**ADDENDUM NO. 2**

Date: August 31, 2018  
Project: **Secondary Treatment Plant Upgrade & Recycled Water Expansion**  
Job No.: 12600-07/16650-02

The following changes and/or clarifications are hereby made to the Contract Documents, and shall become a part of the Contract Documents dated July 2018.

### **1989 Reference Drawings for “Box” Structures to be removed at MMWD Site**

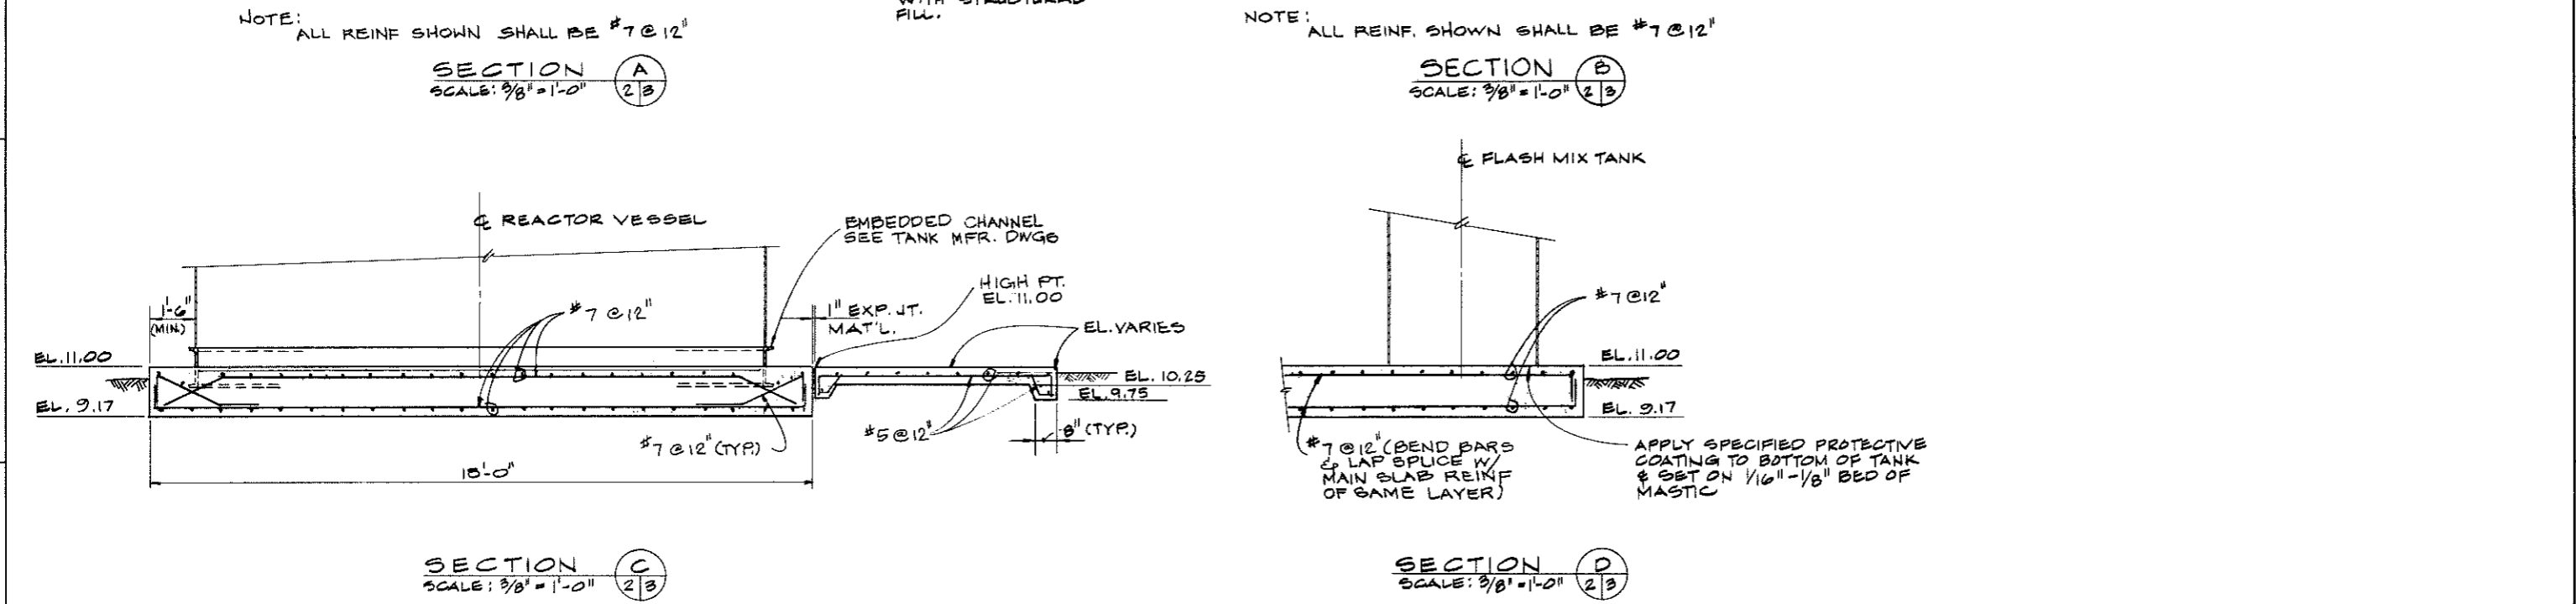
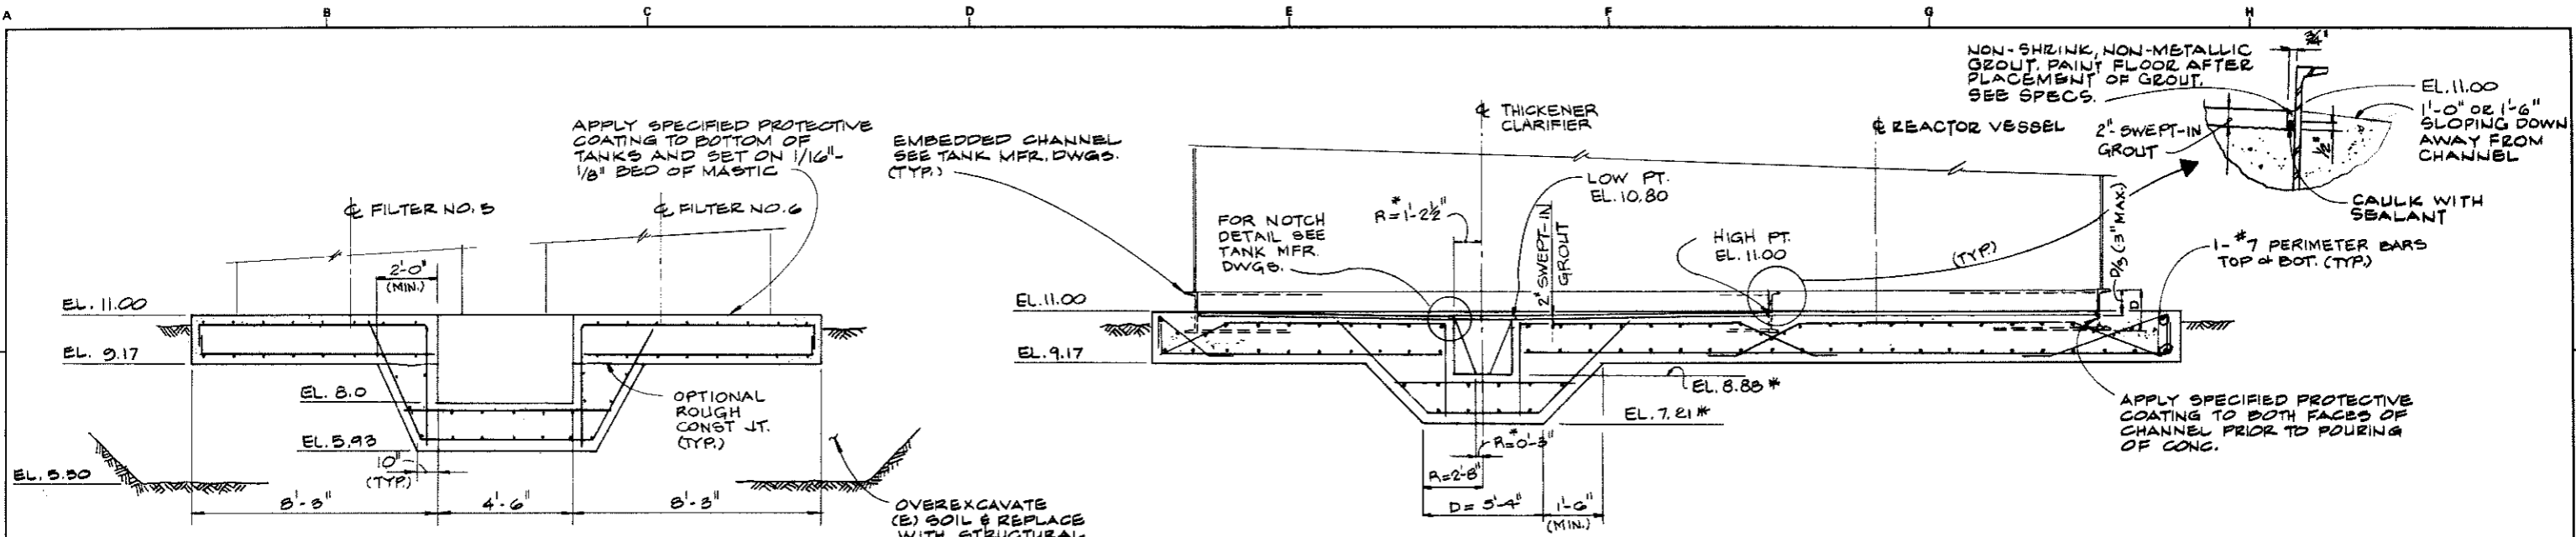
7. Drawing MMD-5 describes Tags 7 and 12 as "Box", but only provides a pad dimension. Provide all dimensions of a box if in fact it is, to be verified during demolition.

### **1982 Reference Drawings for Deep Bed Filter Trough Structures**

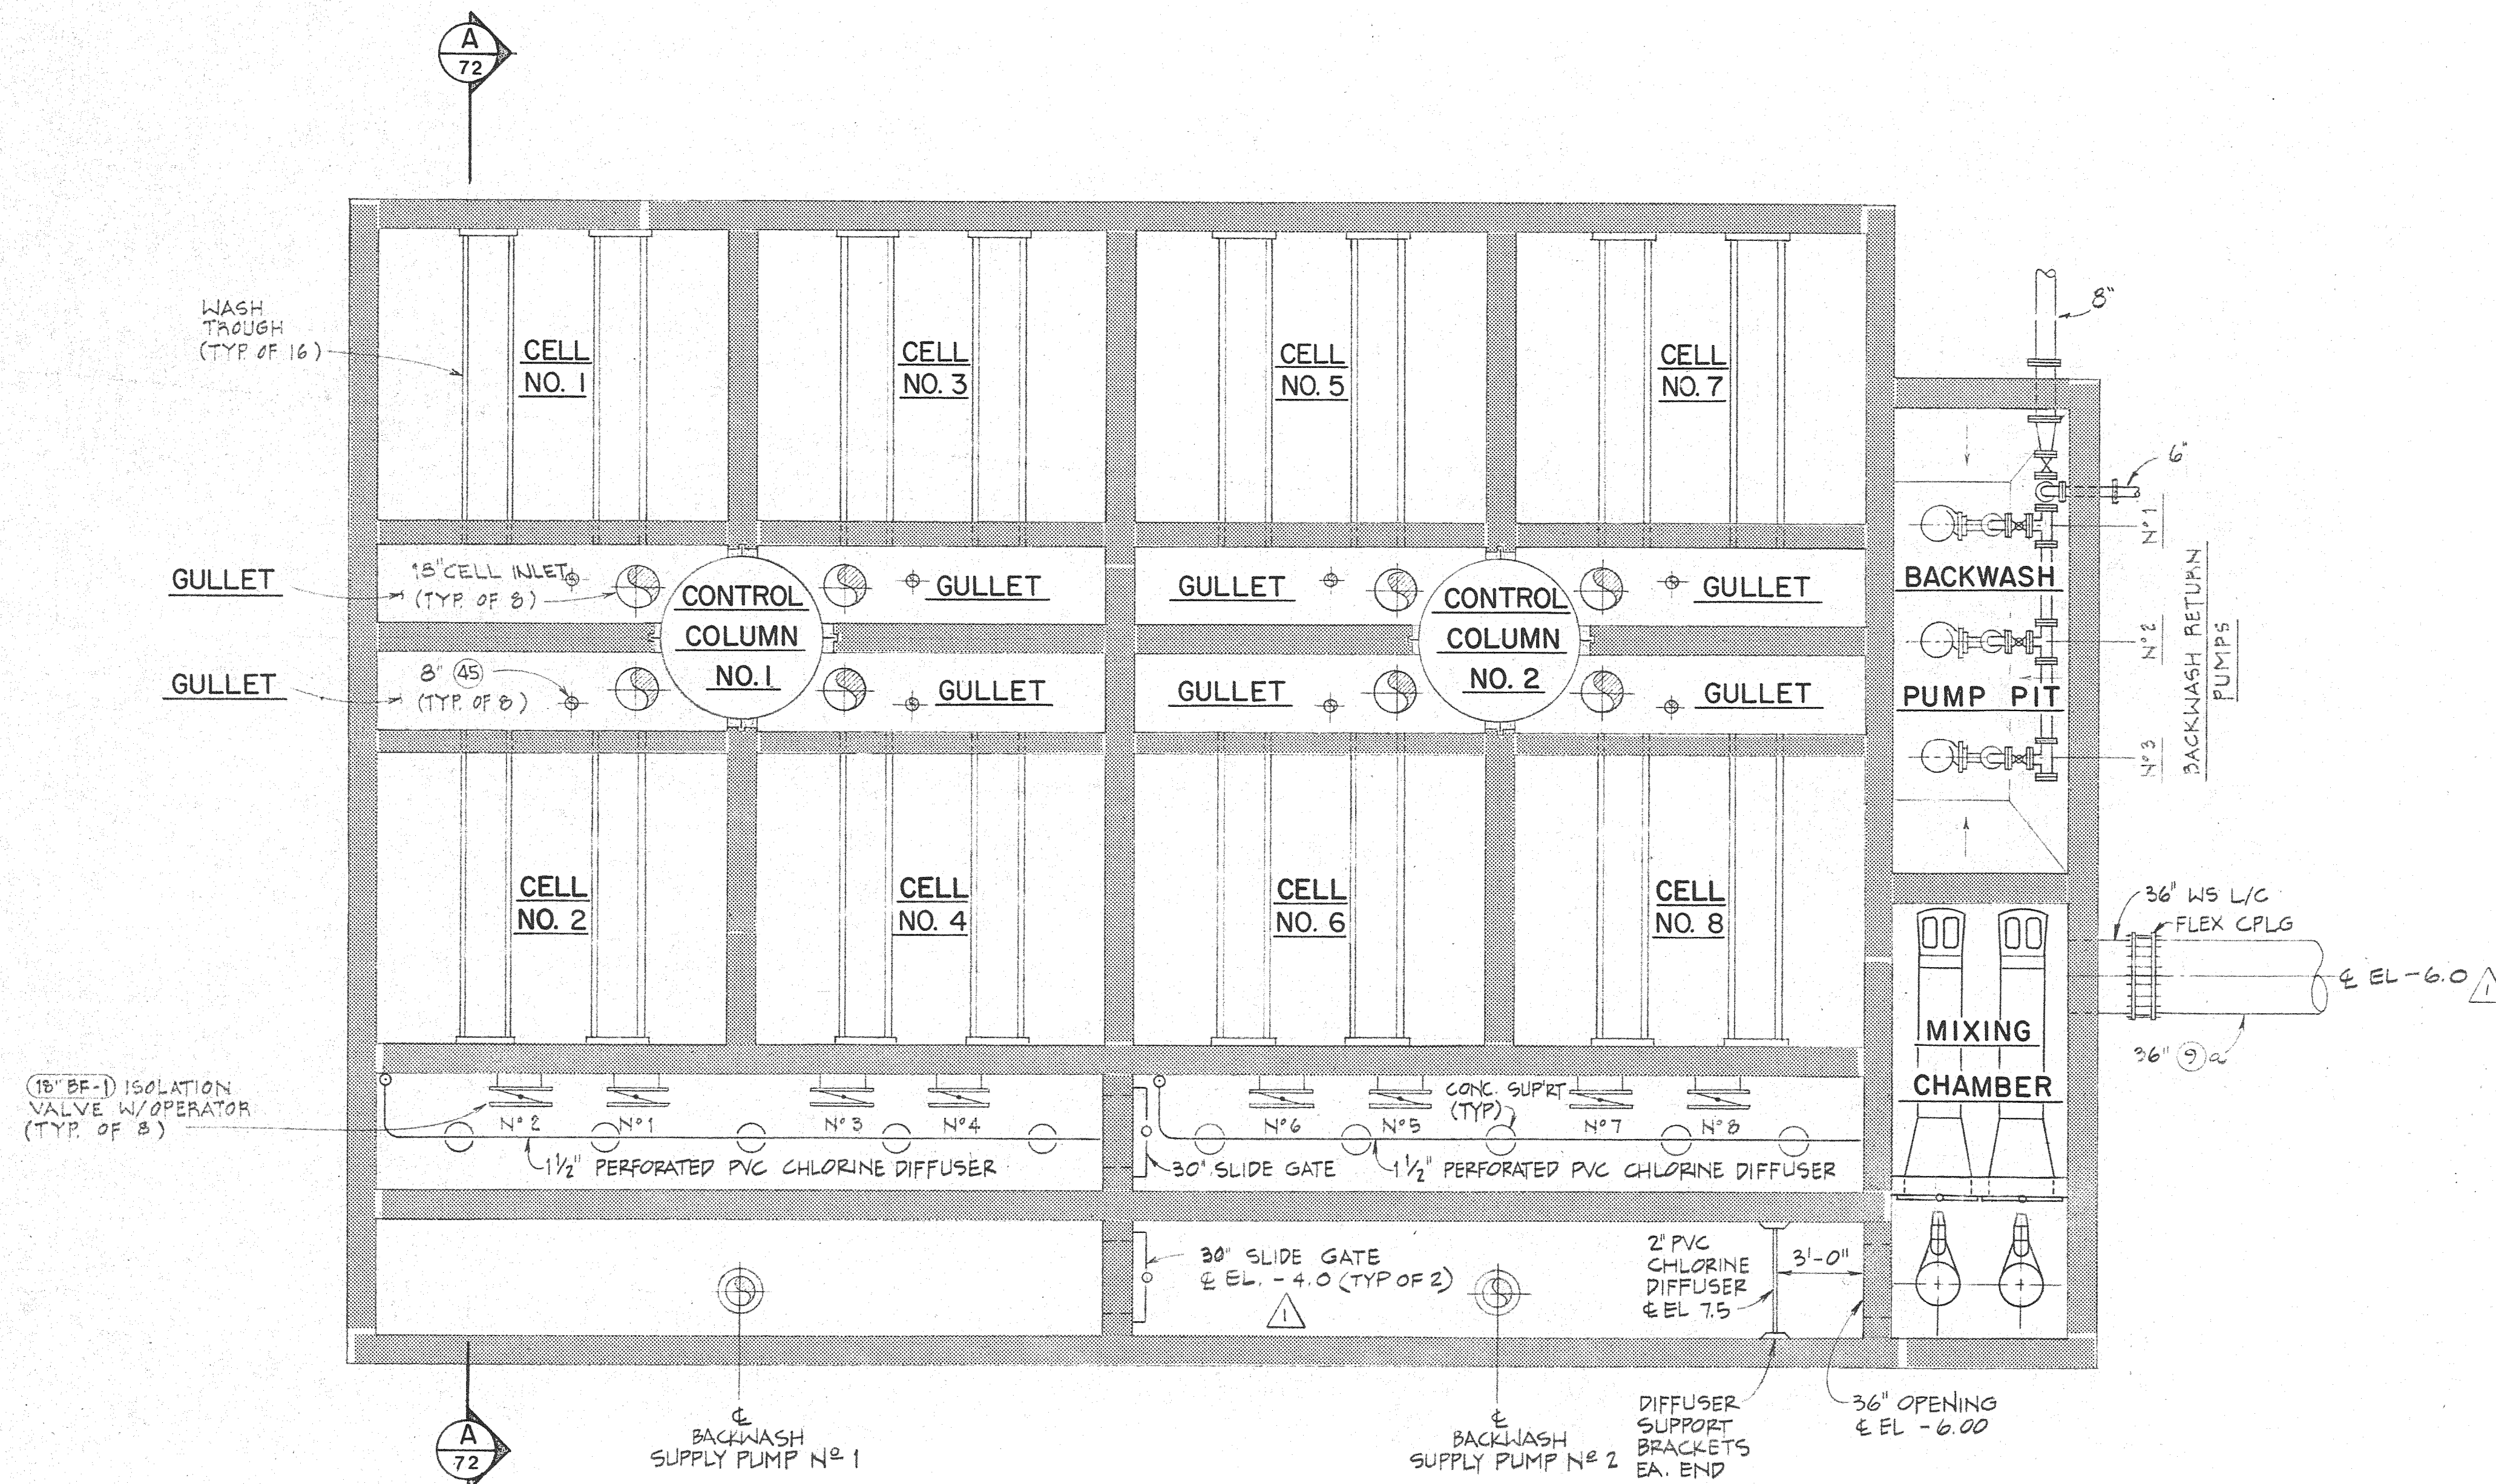
5. Drawing FFD-2 indicates the removal and disposal of Wash Troughs. Provide the material of construction for these WT's. Indicate on FFD-1 where these WT's are located.

**Plan view of the existing troughs from 1982 record drawings is provided as an attachment (Attachment D) to this addendum for reference. The records indicate that these troughs are constructed from 1/4" thick hot dip galvanized plate.**
